SUBJECT: Forwards Addendum to 791231 rept, "Status Rept to NRC from Util, Responding to Nureg-0578: TMI-2 Lessons Learned Task Force Status Rept & Short-Term Recommendations & Clarifications." Addendum responds to re 800109 meeting

Re: Docket No. 50-275  
Docket No. 50-323  
Diablo Canyon Units 1 and 2

STATUS REPORT TO THE  
NUCLEAR REGULATORY COMMISSION  
FROM  
THE PACIFIC GAS AND ELECTRIC COMPANY  
RESPONDING TO  
NUREG-0578:  
"TMI-2 LESSONS LEARNED TASK FORCE  
STATUS REPORT AND  
SHORT-TERM RECOMMENDATIONS"  
AND CLARIFICATIONS

ADDENDUM January 25, 1980

PROCESS CONNECTION SCHEMATIC (TRAIN A)

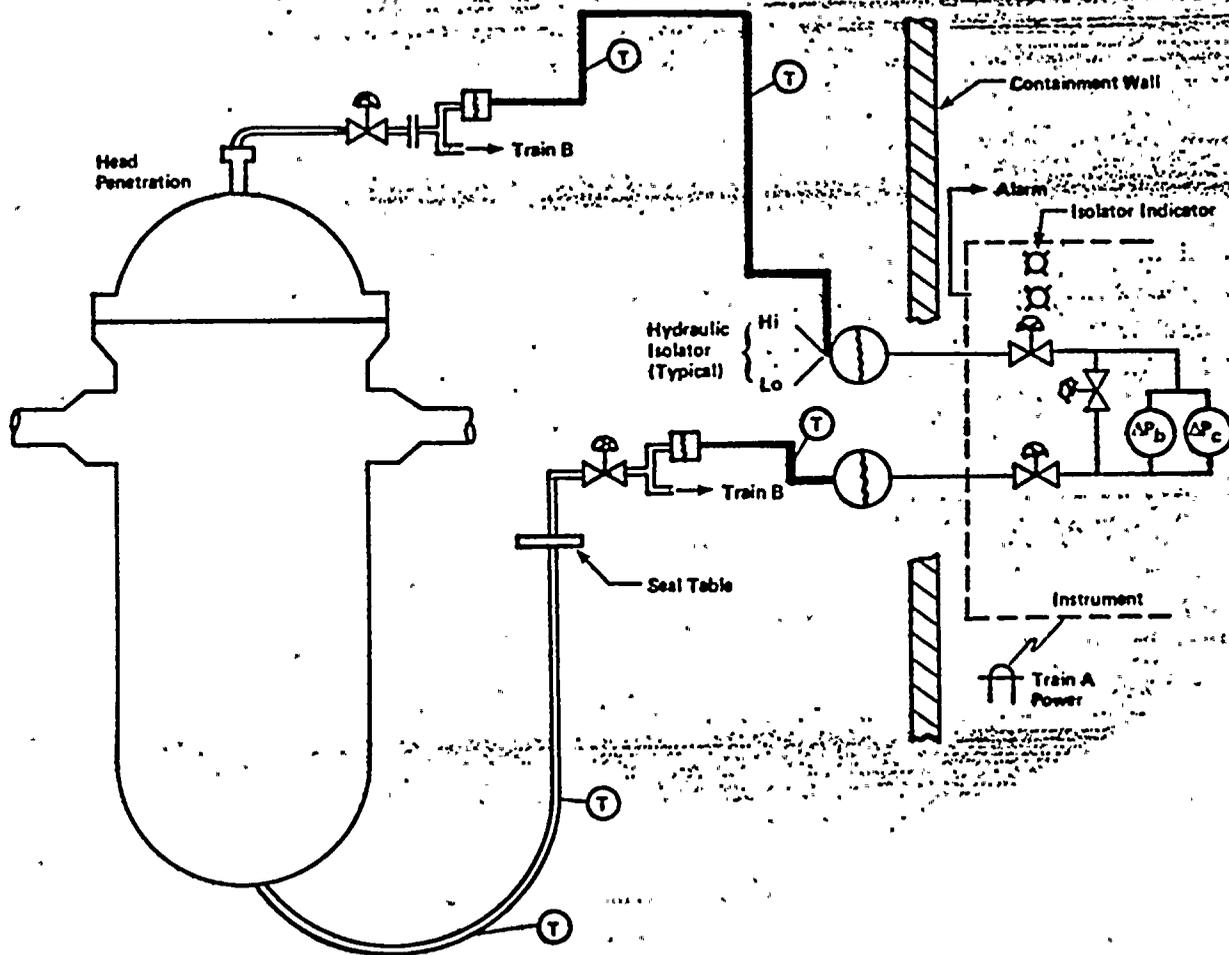
The attached figure shows a simplified sketch of the proposed vessel level instrumentation system. The bottom tap of the instrument would use a thimble of the incore movable detector system either at the seal table or in the thimble below the vessel. Use of the thimble as part of the incore flux monitoring would not be lost. The flux thimble guide tube would be tapped below the vessel and an instrument line connection made. The instrument line would have an isolation valve and slope down to a hydraulic coupler connected to a sealed reference leg. The sealed reference leg would go to the differential pressure transmitter located at a higher elevation above the expected level of containment flooding. A similar sealed leg would go to the top of the vessel and penetrate the head using the vent line or a special connection on a spare RCC mechanism penetration. Two trains of vessel level instrumentation would be provided.

The behavior of the signal generated by this level instrument under normal and accident conditions is being evaluated. The usefulness of this instrument to provide an unambiguous indication of inadequate core cooling is being evaluated as part of Item 2.1.9. The potential errors and accuracy

eds+nuclear  
 CONCEPTUAL DESIGN FLOW  
 DIAGRAM FOR LIQUID REMOTE  
 SAMPLING SYSTEM  
 FIGURE 1

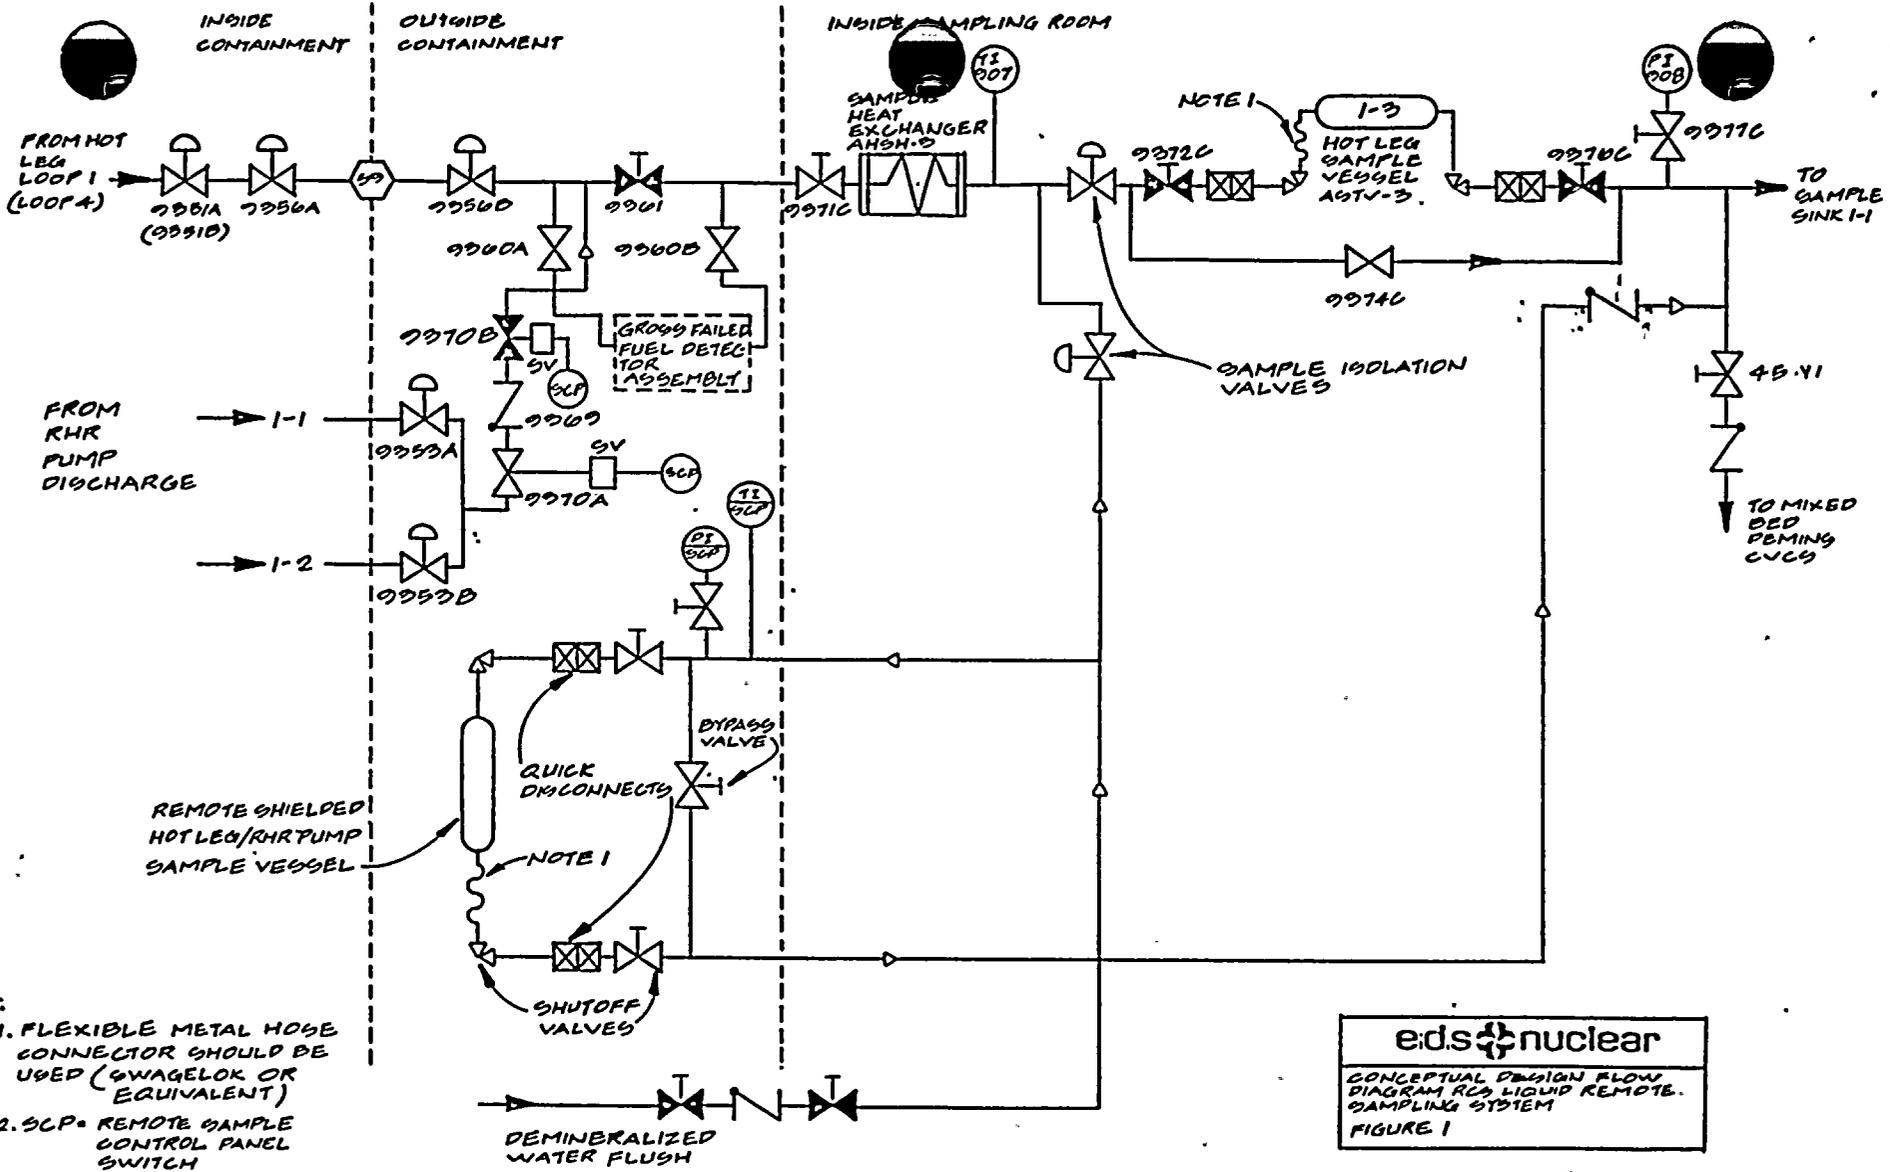
The Remote Sample System, shown in Figure 1, will utilize new isolation sample valves downstream of the sample heat exchanger to divert flow to a shielded, removable sample vessel for obtaining a reactor coolant sample. The shielded sample vessel may be used to obtain coolant samples from either the RHR pump discharge or hot leg 1 or 4 depending on valve line up. Capability to control valves 9370A and B must be provided on the remote sample system panel, due to the fact that the radiation level of the lines those lines are mounted on would preclude personnel access. The reactor coolant returns to the CVCS mixed bed demineralizers to allow the sample to flow to the liquid radwaste system. This minimizes potential gas releases from the sample sink to the auxiliary building atmosphere.

The other alternative allows collection of sample in a length of shielded tubing designed to obtain a 35 ml sample with shutoff valves and quick disconnects as shown in Figure 1. The smaller sample volume minimizes shielding and handling requirements, reduces the exposure potential, and would be simpler to fabricate. The connections at the sample station will be designed to accept both the 100 ml kerotest vessel and a 35 ml "sample tube" so that the capability exists to take either small or large RCS samples. The shielded sample tube will be the primary sample collection method used due to the advantages discussed previously.

Figure 3  
Reactor Coolant Liquid  
Surface Dose Rate vs Radial Shield Thickness

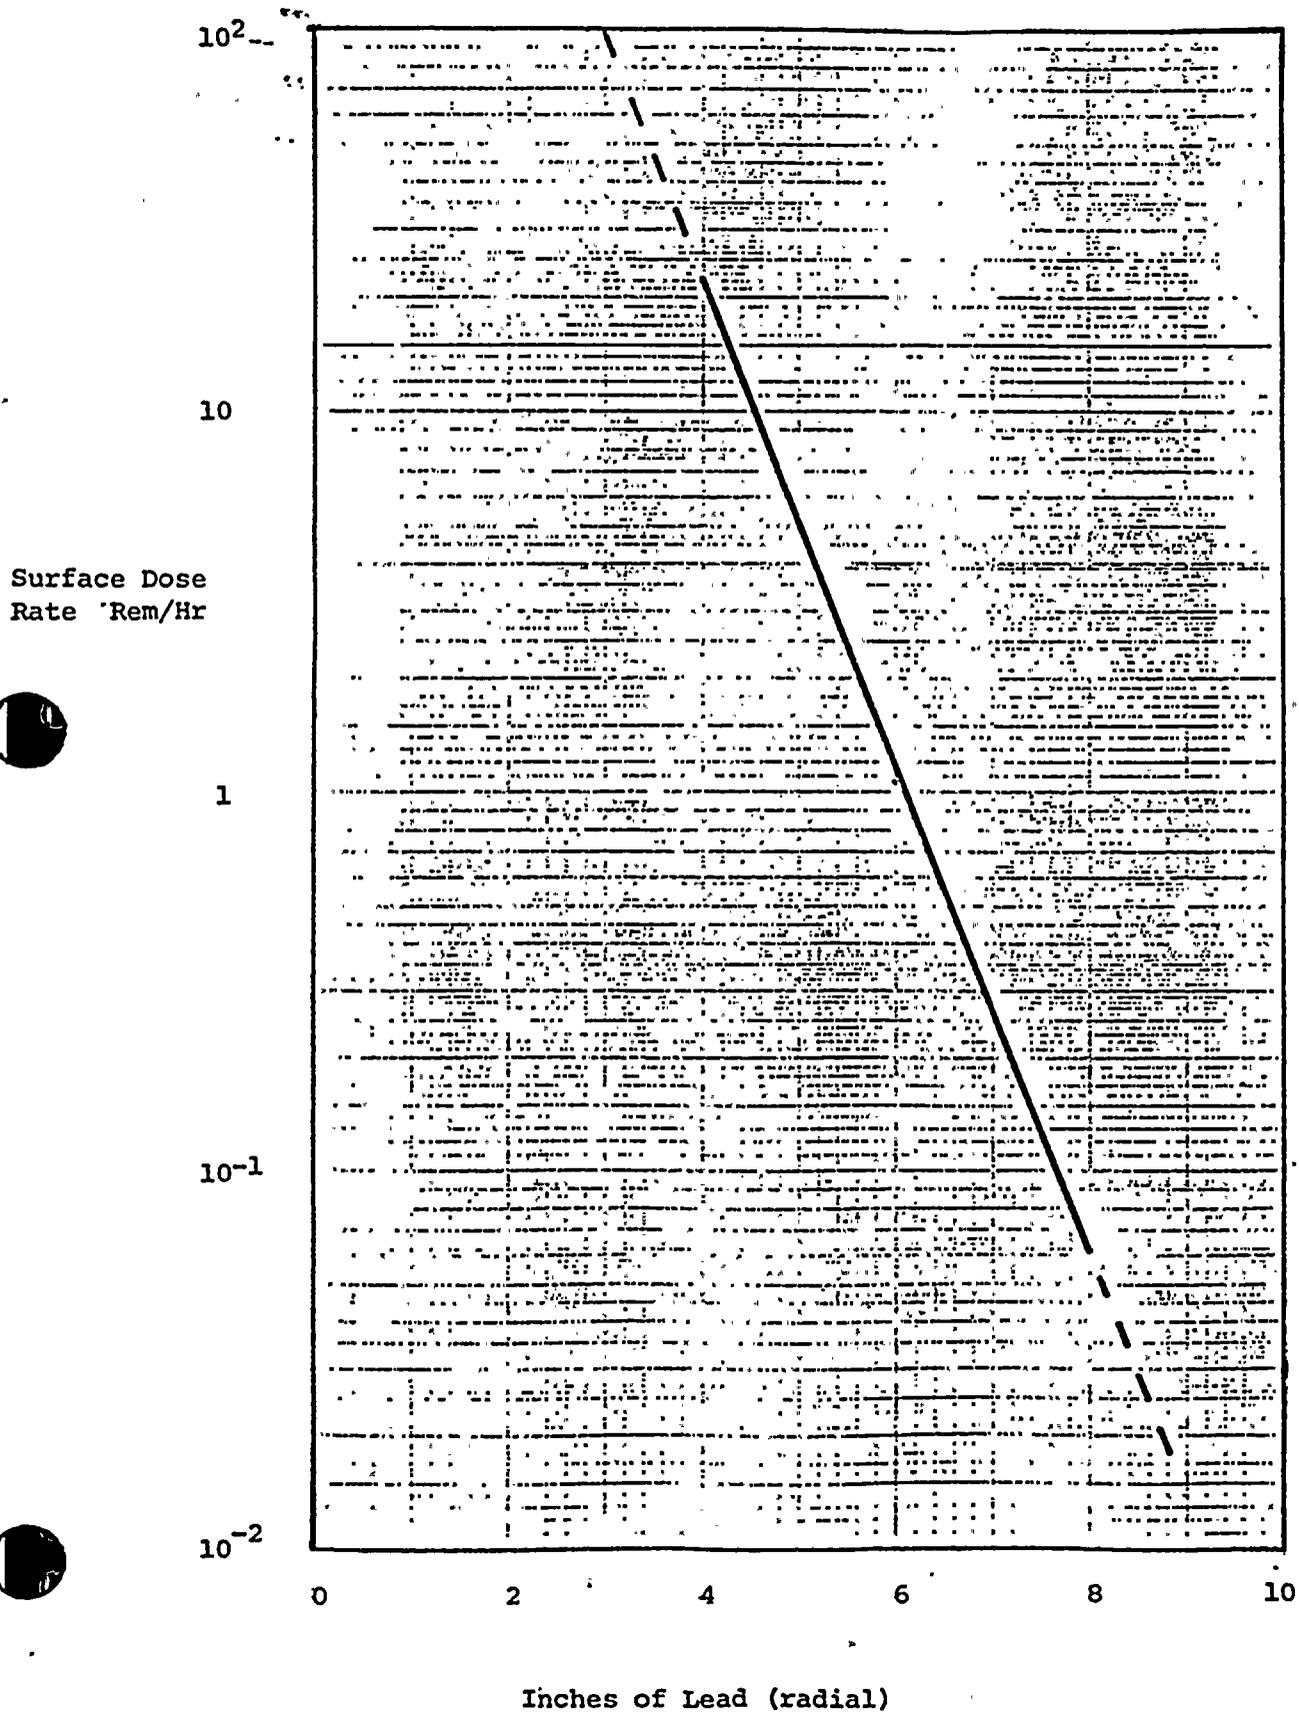
Two sample container attachments were considered. The 100 ml sample vessel supplied by the Kerotest Company and used for normal RCS sampling, could be adapted for use at the remote sampling station. It would require additional shielding but has the advantage of being an off-the-shelf item. Figure 3 shows a graph of dose rate vs. shield thickness for a cylindrical shield placed around the kerotest vessel.
